product modification

050-2239-03

Q935, Q946, Q947, OR Q9070 REPLACEMENT

For the following TEKTRONIX[®] Oscilloscopes:

Fig. 1. Component locations on Main board before modifications.

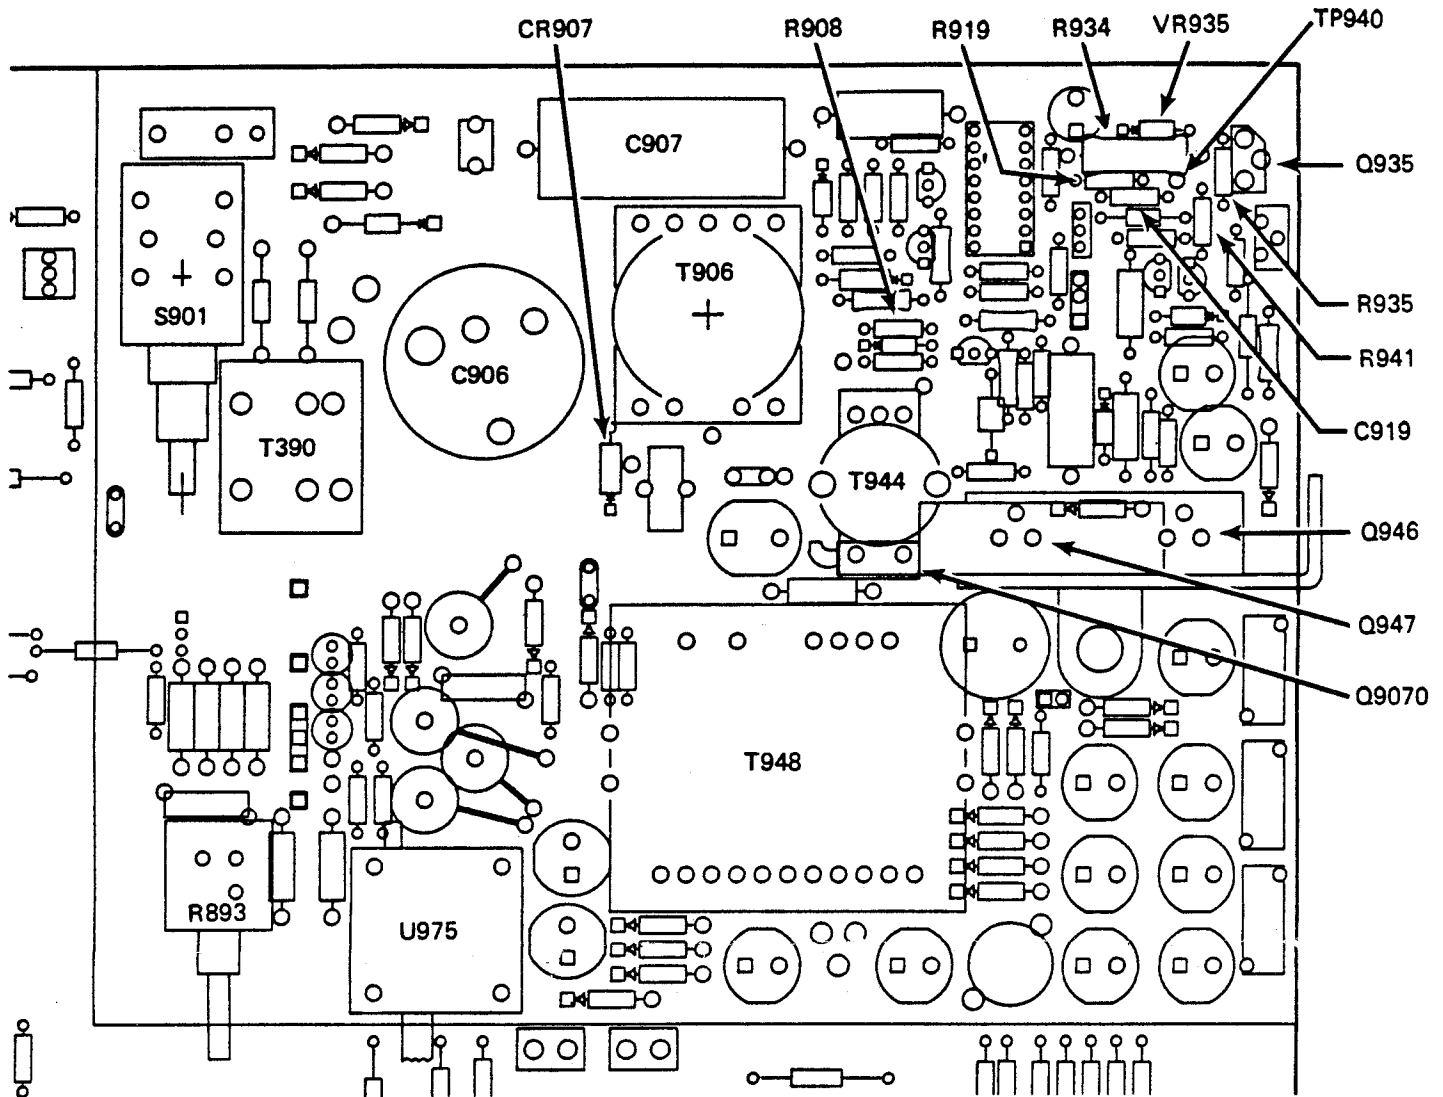
Make the following changes on the A1 Main board. Refer to Fig. 1.

New components have been provided in this kit to facilitate relocating the components in the following step. Note that R934 is being replaced with a 0Ω dummy resistor, W934, and that three resistor values have been provided for R919. At some frequencies the power supply emits an audible noise which may be eliminated by selecting the value of R919.

- () 6. Relocate C919, R919, R934, R935, R941 and VR935 from the component side of the Main circuit board to the solder side of the circuit board. Note which circuit board pads each component uses to facilitate installation of the components on the solder side of the circuit board.

Fig. 2. SCR Installation

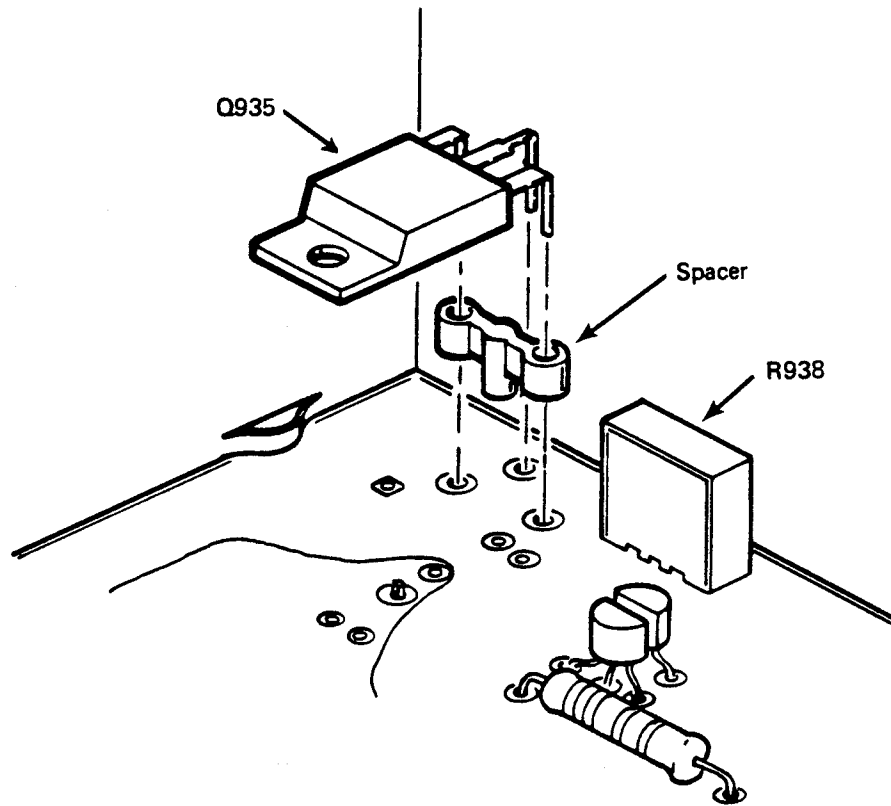
The new silicon control rectifier, pn 151-0565-01, used to replace Q935 has improved current characteristics. To prevent interference between the new SCR and the electronics module of the fan assembly, the SCR was laid down on the circuit board which required several components to be relocated.

- () 8. Replace R908, a $3k\Omega$ 0.25W resistor, with the $2.2k\Omega$ resistor included in this kit.
- () 9. Prepare the two diodes included in this kit so that they are in parallel and the cathodes are tied together. Replace CR907 with the pair of diodes, CR906 and CR907.
- () 10. Replace Q946, Q947, and Q9070 with the new components included in this kit. Q946, Q947 and Q9070 are located on the metal bracket attached to the right rear corner of the chassis. Refer to the parts list on page 3 for circuit and part number information.
- () 11. Replace Q935 with the new SCR, included in this kit, using the included spacer as shown in Fig. 2.
